From:	Tim Girmscheid
Cc:	Quincy Bejster; Kristy De Boer; Theodora Anderson; Josue Pasillas
Bcc:	
Subject:	RE: Request for Quotes: Barrier Fence Replacements CLARIFICATION
Date:	Wednesday, February 17, 2021 3:13:00 PM
Attachments:	image003.png image005.png

2021 BARRIER FENCE REPLACEMENTS

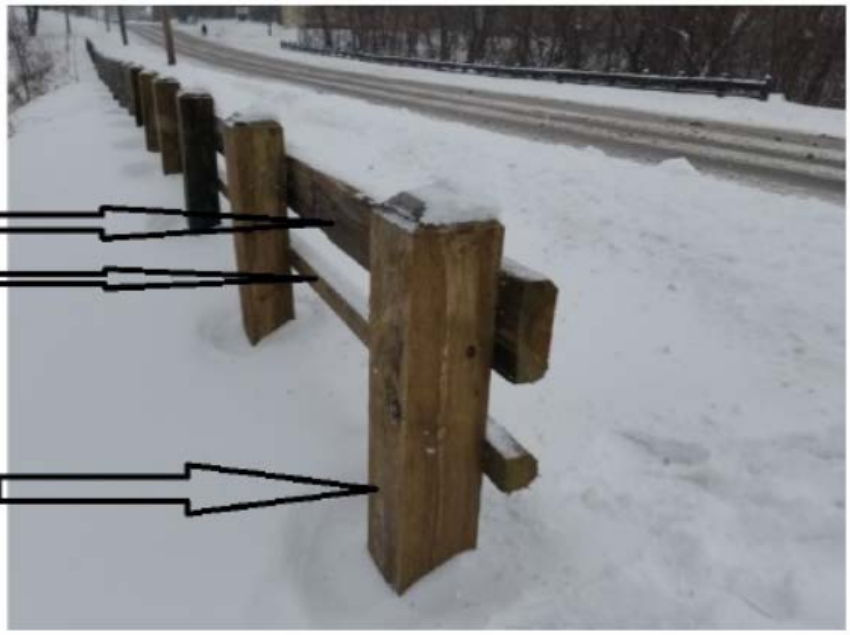
Since the snow is making it difficult to access the existing fences, we are providing the snapshots of the fabricating, hardware and install. Disregard the reference to 6’ spacing. We are using 8’ spacing for this project. Let me know if you have any questions. Thanks.

4x10 Standard Ground Contact Pressure Treated beveled rail.

4x4 Standard Ground Contact Pressure treated beveled rail.

6ft. o.c. Spacing 8x8 Heavy Ground Contact UC4B IDOT Spec Post. Holes 42" d x 15" min dia set in concrete. Apprx. 36" above grade beveled tops.

Hex Bolts, Hot dipped galvanized steel, 5/8"x11x11", including hot dipped galv. steel hex nuts and flat washers.
